RE: Request for Additional Data #8 – Certificate of Public Convenience and Necessity for the Sycamore-Peñasquitos 230-Kilovolt Transmission Line Project – Application No. A. 14-04-011

REQUEST FOR ADDITIONAL DATA: DATA NEEDS #8 FOR THE SYCAMORE-PEÑASQUITOS 230-KILOVOLT TRANSMISSION LINE PROJECT APPLICATION (A. 14-04-011)

Alternative Routes Under Consideration

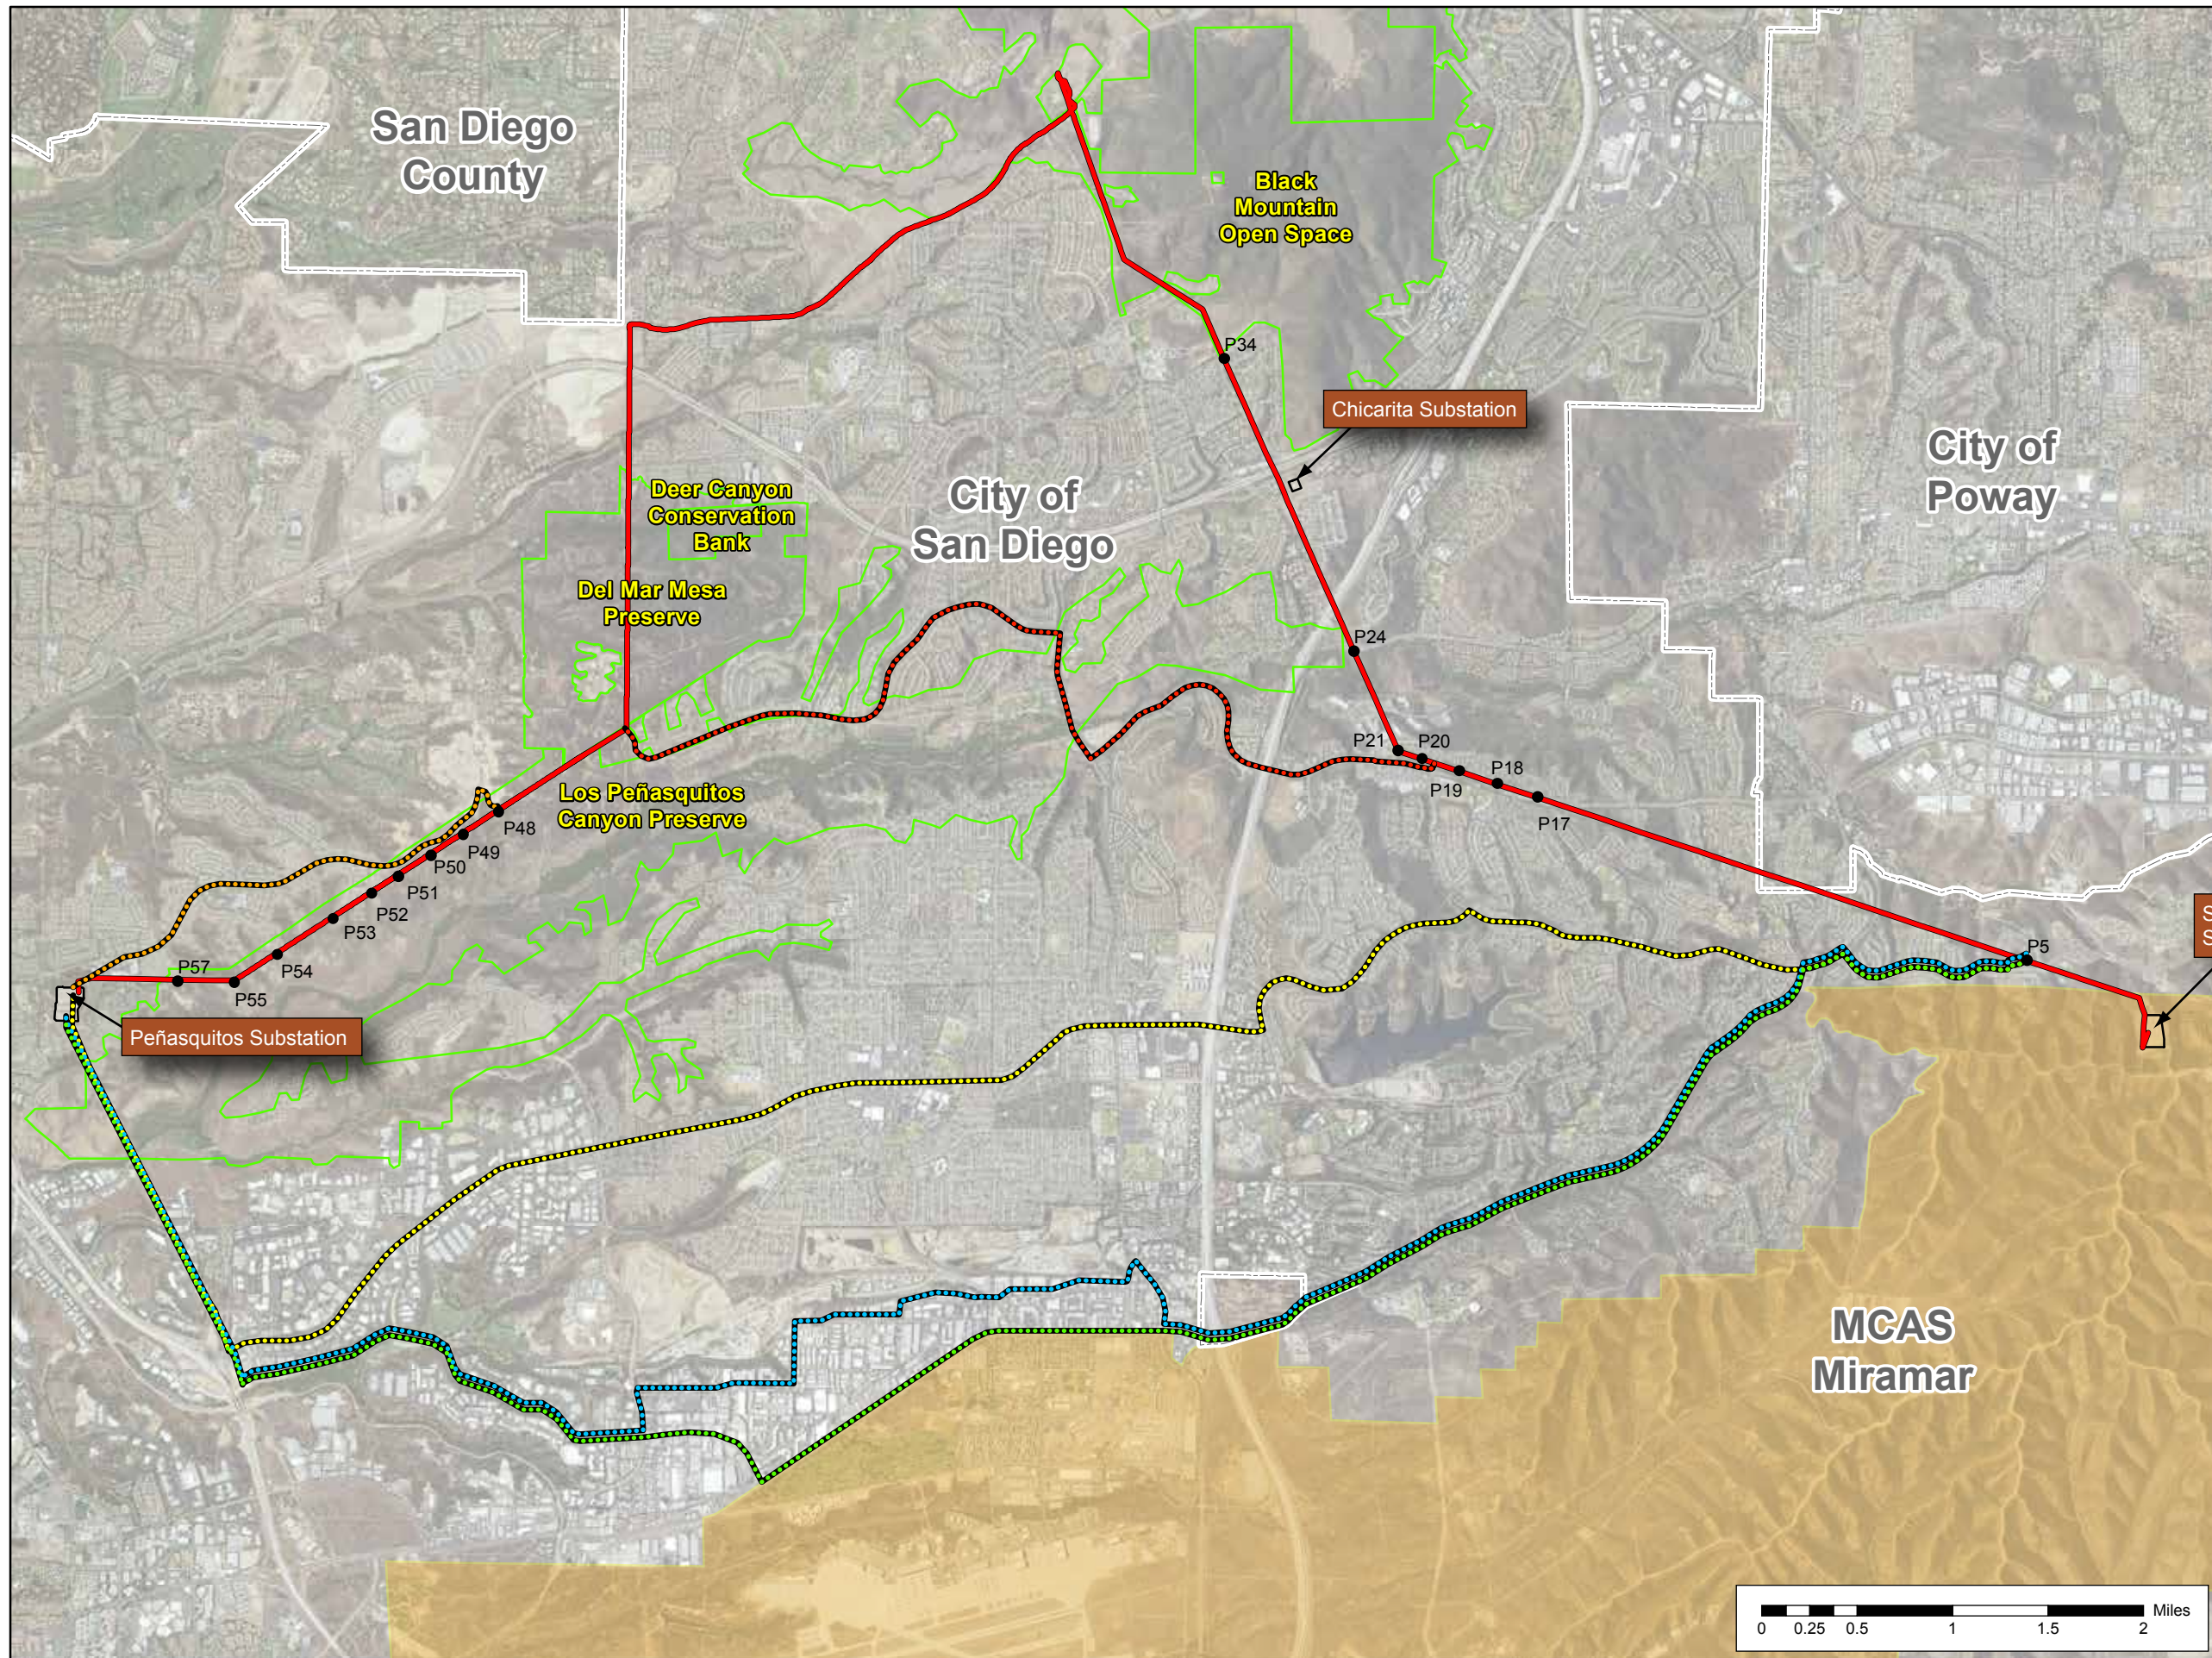
4	N/A	<p>Provide preliminary engineering for a Stonebridge – Mira Mesa Combined Underground and Overhead Alternative under consideration by the CPUC environmental team.</p> <p>Preliminary engineering is required for an alternative extending underground from Stonebridge Parkway in Segment A to Vista Sorrento Parkway (south of Segment D)</p>

#	PEA Section, Page #	Data Need
		<p>and overhead from Vista Sorrento Parkway to the Peñasquitos Substation via Mira Mesa Blvd. The alternative alignment is shown in Attachment A. The alternative follows the proposed alignment of Segment A from Sycamore Substation to Stonebridge Parkway. The alternative would transition to underground in Stonebridge Parkway via a cable pole approximately 340 feet east of Stonecroft Terrace. The alignment would travel west via Stonebridge Parkway to Pomerado Road, then west within Pomerado Road to and continuing within Spring Canyon Road. Where Spring Canyon Road turns north the route would follow Scripps Ranch Blvd to the west to the intersection with Mira Mesa Blvd. The route would continue west in Mira Mesa Blvd to Vista Sorrento Parkway. At Vista Sorrento Parkway the line would transition to overhead and follow an existing SDG&E ROW to the north to Peñasquitos Substation.</p> <p>Provide preliminary engineering, design, and impact information as requested under item 3 above.</p> <p>In addition, identify what circuits are in the existing right-of-way from the area of Vista Sorrento Parkway to Peñasquitos Substation and what types of structures exist in the right-of-way. Identify the width of the existing right-of-way and dimensions between the existing lines and right-of-way boundaries.</p>

5		<p>Provide preliminary engineering for a Pomerado Road – Miramar Area North Combined Underground and Overhead Alternative under consideration by the CPUC environmental team.</p> <p>Preliminary engineering is required for an alternative extending underground from Stonebridge Parkway in Segment A to Vista Sorrento Parkway (south of Segment D) and overhead from Vista Sorrento Parkway to the Peñasquitos Substation via the Miramar Area North commercial roadways. The alternative alignment is shown in Attachment A. The alternative follows the proposed alignment of Segment A from Sycamore Substation to Stonebridge Parkway. The alternative would transition to underground in Stonebridge Parkway via a cable pole approximately 340 feet east of Stonecroft Terrace. The alignment would travel west via Stonebridge Parkway to Pomerado Road, then west within Pomerado Road to I-15. The line would be attached to the Pomerado/ Miramar Road bridge over I-15 or on an overhead structure crossing I-15. The route would continue westward underground beneath Miramar Road, turn north on Kearny Villa Road, west on Black Mountain Road, west on Activity Road to Camino Ruiz. The line would continue underground north under Camino Ruiz, west on Miralani Drive, west on Arjons Drive, south on Trade Place, west on Trade Street, south on Camino Santa Fe, and west on Carroll Road/Carroll Canyon Road to Vista Sorrento Parkway. At Vista Sorrento Parkway the line would transition to overhead and follow an existing SDG&E ROW to the north to Peñasquitos Substation.</p> <p>Provide preliminary engineering, design, and impact information as requested under item 3 above.</p> <p>In addition, identify what circuits are in the existing right-of-way from the area of Vista Sorrento Parkway to Peñasquitos Substation and what types of structures exist in the right-of-way. Identify the width of the existing right-of-way and dimensions between the existing lines and right-of-way boundaries.</p>

6		<p>Provide preliminary engineering for a Pomerado Road – Miramar Road Combined Underground and Overhead Alternative under consideration by the CPUC environmental team.</p> <p>Preliminary engineering is required for an alternative extending underground from Stonebridge Parkway in Segment A to Vista Sorrento Parkway (south of Segment D)</p>

#	PEA Section, Page #	Data Need
		<p>and overhead from Vista Sorrento Parkway to the Peñasquitos Substation via Miramar Road. The alternative alignment is shown in Attachment A. The alternative follows the proposed alignment of Segment A from Sycamore Substation to Stonebridge Parkway. The alternative would transition to underground in Stonebridge Parkway via a cable pole approximately 340 feet east of Stonecroft Terrace. The alignment would travel west via Stonebridge Parkway to Pomerado Road, then west within Pomerado Road to I-15. The line would be attached to the Pomerado/ Miramar Road bridge over I-15 or on an overhead structure crossing I-15. The route would continue westward underground beneath Miramar Road to Carroll Road/Carroll Canyon Road where it would continue west on Carroll Road to Vista Sorrento Parkway. At Vista Sorrento Parkway the line would transition to overhead and follow an existing SDG&E ROW to the north to Peñasquitos Substation.</p> <p>Provide preliminary engineering, design, and impact information as requested under item 3 above.</p> <p>In addition, identify what circuits are in the existing right-of-way from the area of Vista Sorrento Parkway to Peñasquitos Substation and what types of structures exist in the right-of-way. Identify the width of the existing right-of-way and dimensions between the existing lines and right-of-way boundaries.</p>

Alternative Cable Pole Underground Routes Under Consideration

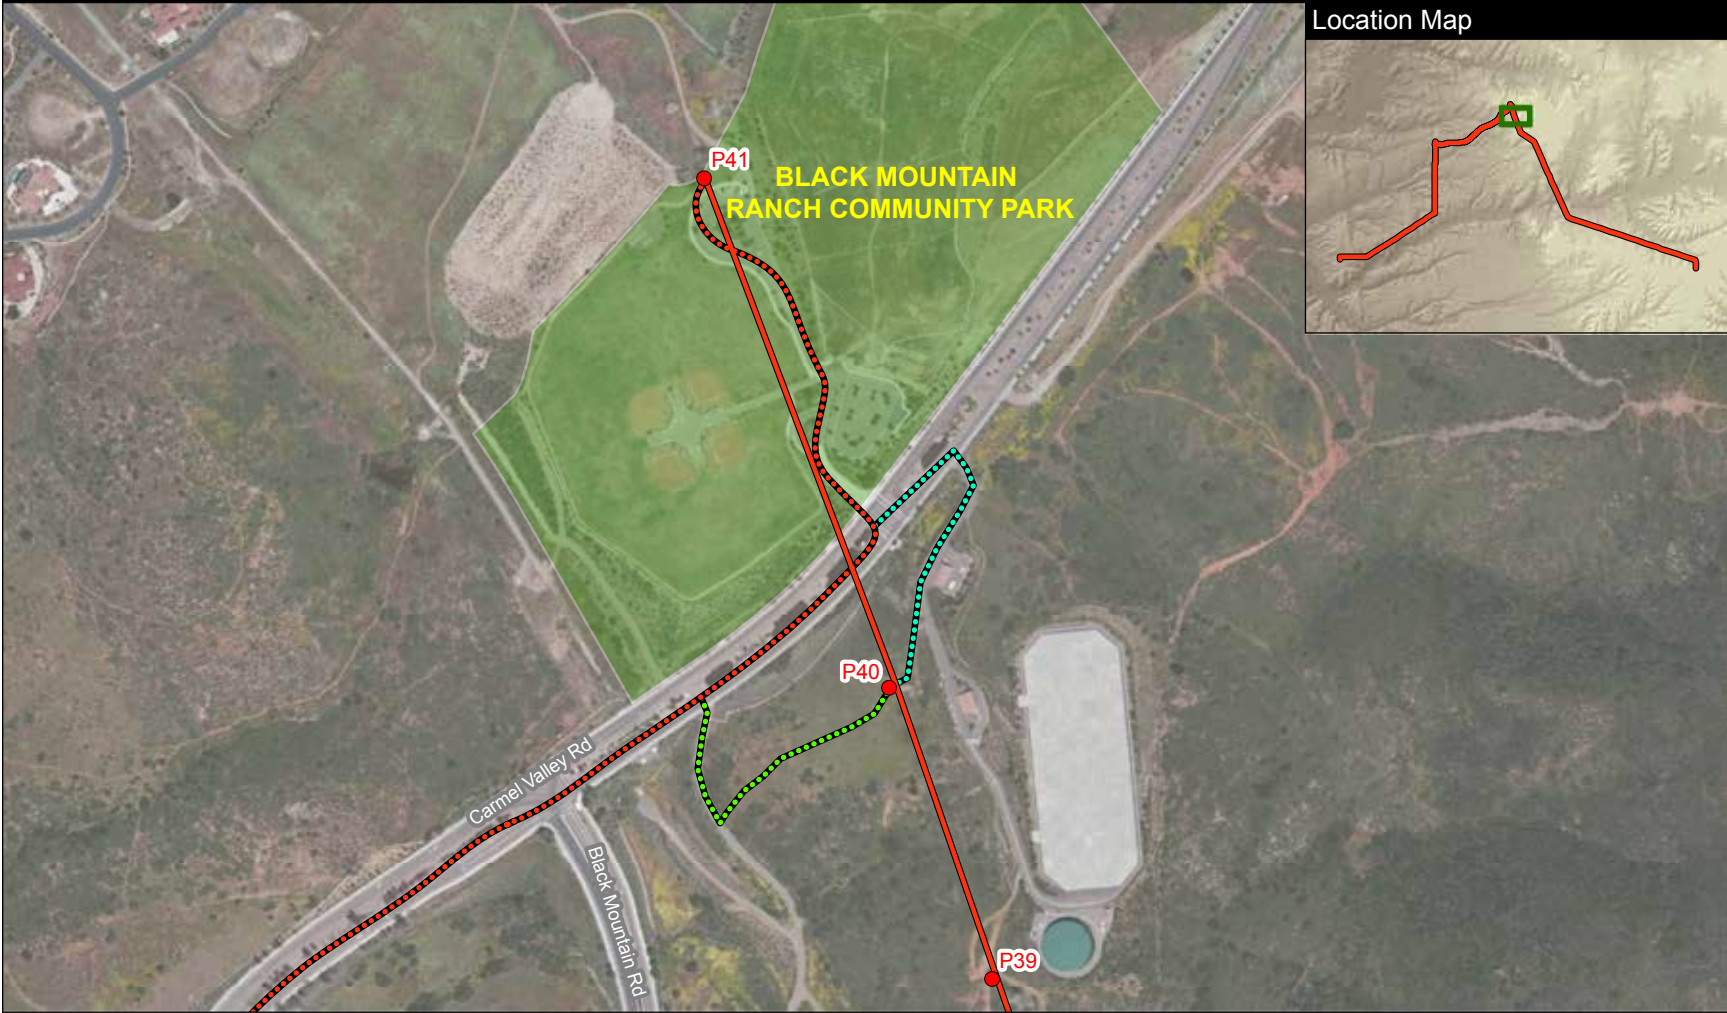
9	N/A	<p>Provide preliminary engineering for two potential underground alternatives from a cable pole located south of Carmel Valley Road at the east end of the underground line under consideration by the CPUC environmental team.</p> <p>Preliminary engineering is needed for an alternative cable pole location south of Carmel Valley Road at the approximate location of the first existing structure south of Carmel Valley Road. There are two potential underground alignments between the cable pole and Carmel Valley Road as shown on Attachment C:</p> <p>5) Northeasterly for a short distance (approximately 200 feet) along SDG&E access road to a paved road within the water reservoir facility north of the ROW. The route would be within the road for approximately 450 feet to Carmel Valley Road</p> <p>6) West and parallel to Carmel Valley Road from the cable pole along an existing access trail to an existing main access road to Emden Road where the route then turns north for approximately 400 feet to Carmel Valley Road.</p> <p>Provide preliminary engineering information as requested under item 3 above.</p>
